## SUBDIVISION AUTHORITY MINUTES

### MEETING NO. 39

RE: Tentative plan of subdivision to create 243 single detached residential lots from portions of NE 2-54-24-4 and Block 1, Plan 772 2209, located west of 50 Street and north of 167 Avenue; **McCONACHIE**

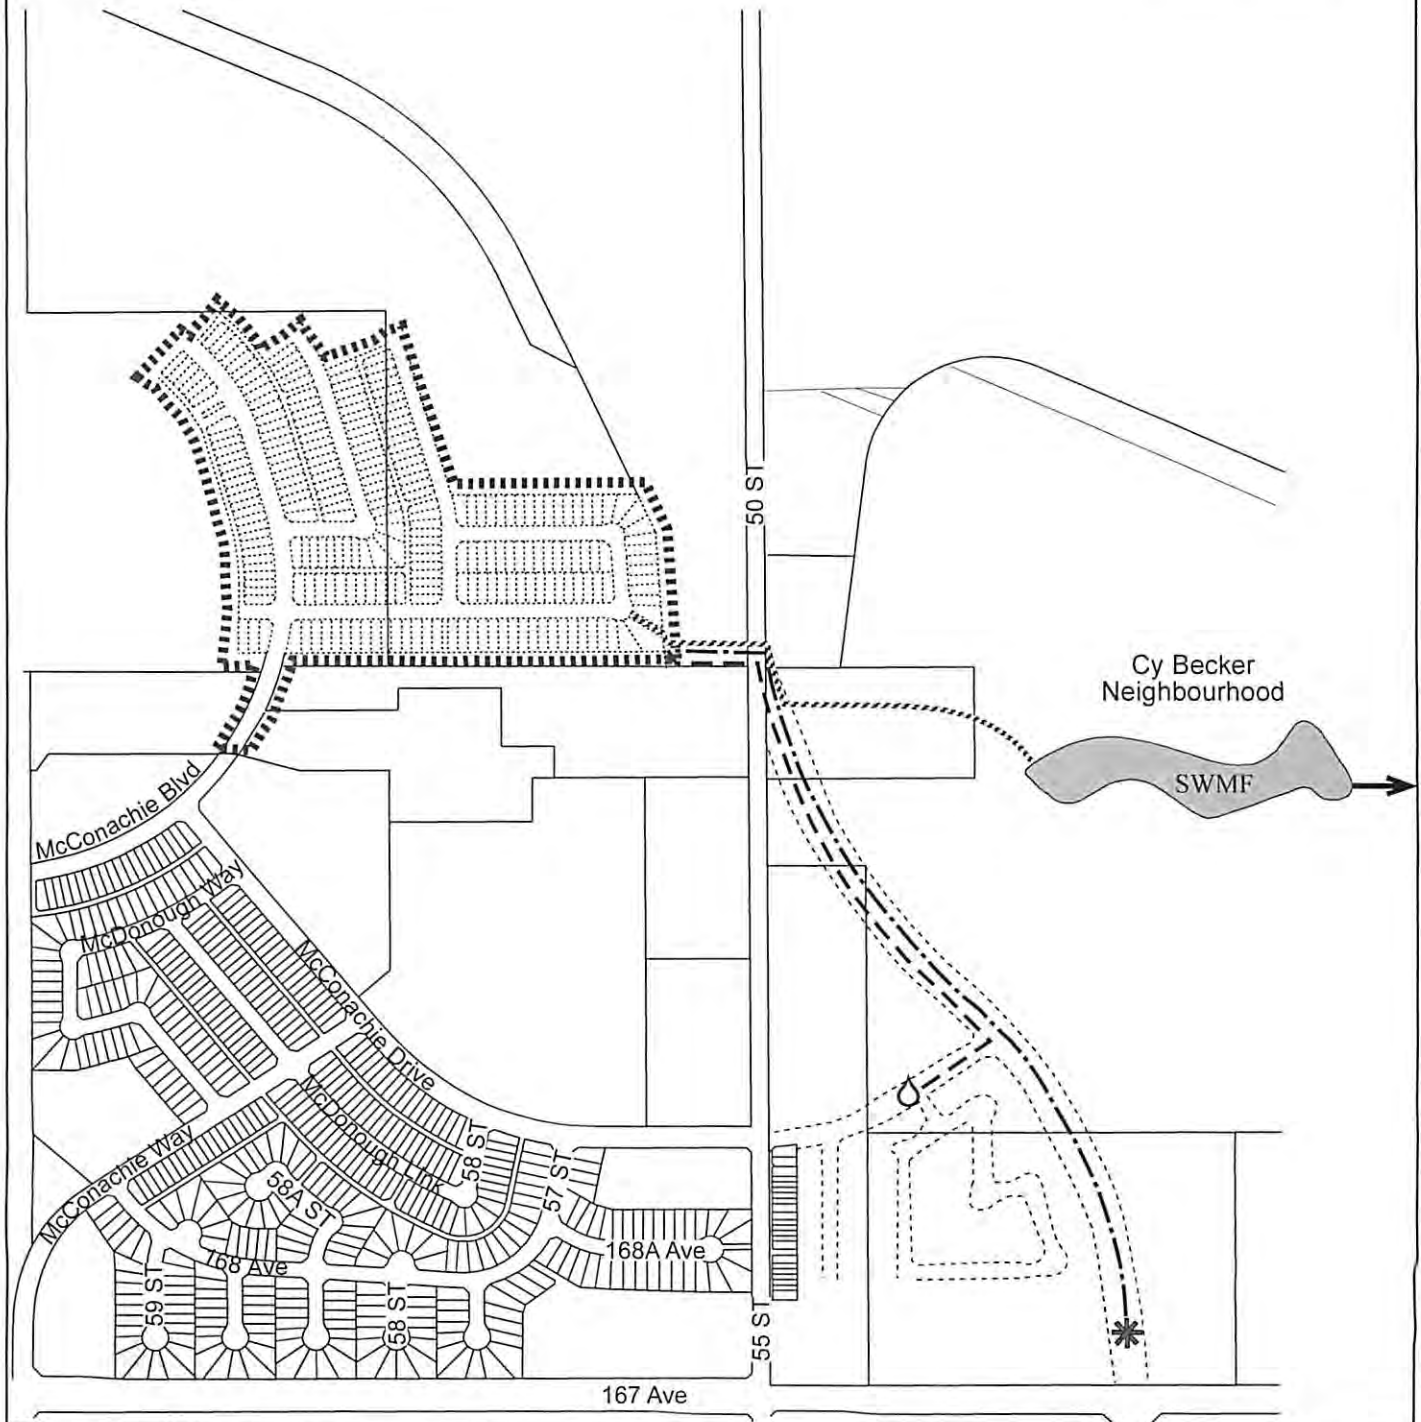
8. that the engineering drawings include the design and construction of the North Cy Becker Storm Water Management Facility in its entirety, or to a stage suitable to service this subdivision, as shown on the "Conditions of Approval" map, Enclosure II, to the satisfaction of Infrastructure Services;

9. that the engineering drawings include the construction of the permanent storm outlet system from the Cy Becker Neighbourhood, to be located along 34 Street and connected to the Clareview Storm Trunk at 153 Avenue. The portion of this outlet pipe from the Vriend Lake outlet to the Clareview Storm Trunk was identified as a requirement of the Brintnell Stage 17B subdivision (LDA11-0057); however, should the Servicing Agreement for Stage 17B not be signed prior to the Servicing Agreement for this subdivision, the design and construction of this portion of the outlet pipe will be the responsibility of this subdivision;

10. that the engineering drawings include the construction of an offsite sanitary sewer main along the future 50 Street alignment connecting to the existing sanitary sewer stub at 167 Avenue, to the satisfaction of Infrastructure Services, as shown on the "Conditions of Approval" map, Enclosure II;

11. that the engineering drawings include the construction of an offsite 450mm water main along the future 50 Street, to the satisfaction of EPCOR Water Services, as shown on the "Conditions of Approval" map, Enclosure II;

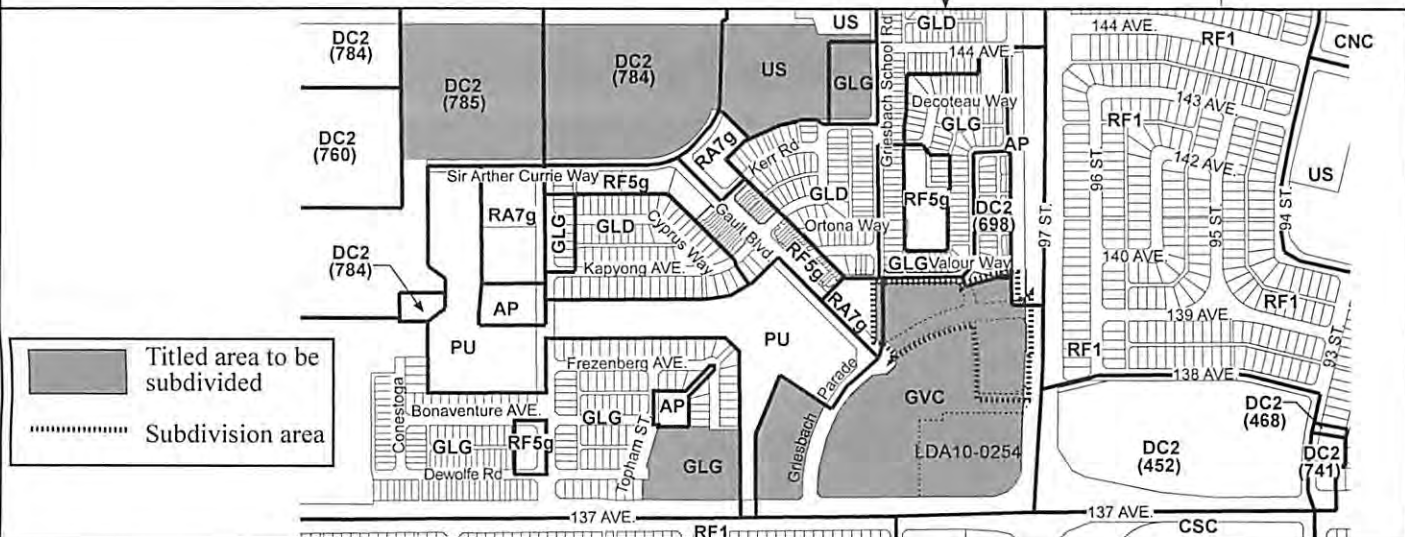
3. that the approved subdivision (LDA10-0254) be registered prior to or concurrent with this application;
4. that a public access easement be registered on the Certificate of Title to allow for public use of the north/south walkway between Griesbach Parade and the Private Road (Village Road), as shown on the "Conditions of Approval" map, Enclosure I;

5. that the owner register a cross lot access easement, as shown on the "Conditions of Approval" map, Enclosure I. The cross lot access easements must state that neither owner can discharge the easement without the express written consent of the City of Edmonton;

6. that the owner provide a walkway to be registered as road right-of-way to the satisfaction of Transportation Services, as shown on the "Conditions of Approval" map, Enclosure I; and

5. that the owner pay for the installation of traffic signals at the intersection of 97 Street and Griesbach Parade, as shown on the "Conditions of Approval" map, Enclosure I. The traffic signal installation is to be coordinated with the construction of the Griesbach Parade and 97 Street intersection, and must be installed and operational when this intersection is opened to traffic;

6. that the owner construct all necessary roadway modifications at the intersection Griesbach Parade and 97 Street, including a northbound left turn bay on 97 Street and a southbound right turn bay on 97 Street, to the satisfaction of Transportation Services and as shown on the "Conditions of Approval" map, Enclosure I;

7. that the owner construct all necessary roadway modifications along 97 Street associated with the right-in/right-out intersection at the Private Road (Village Road). The construction is to include a southbound auxiliary lane on 97 Street from Griesbach Parade to the existing southbound right turn bay on 97 Street at the 137 Avenue intersection, to the satisfaction of Transportation Services and as shown on the "Conditions of Approval" map, Enclosure I;

8. that the owner construct a 1.5 m sidewalk with lighting from the north side of the Private Road (Village Road) to the existing sidewalk at the north edge of the subdivision, as shown on the "Conditions of Approval" map, Enclosure I;

9. that the owner construct a bus stop/shelter pad and connector sidewalk, as shown on the "Conditions of Approval" map, Enclosure I;
10. that the owner construct all fences positioned wholly on privately-owned lands, as shown on the "Conditions of Approval" map, Enclosure I, to the satisfaction of Infrastructure Services, Transportation Services, and Sustainable Development; and
